PM73488

QSE

DATA SHEET Errata

**Released
Issue 6: Feb. , 2002**

Figure 40 (Data sheet Issue 3). Reset Timing

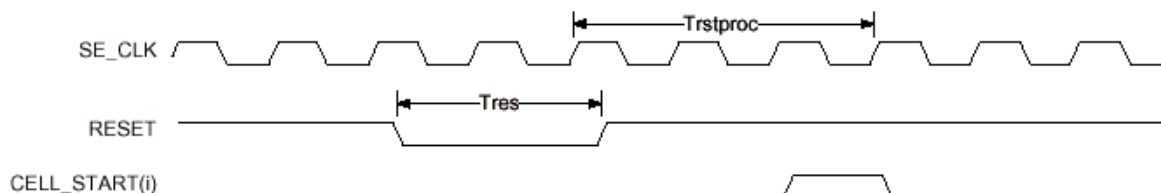
The RESET signal shown in figure 40 of the data sheet (below) is defined as being asserted during the time period (Tres). Since the RESET pin on the QSE is defined as active high, the RESET signal in figure 40 is incorrect and should be inverted.
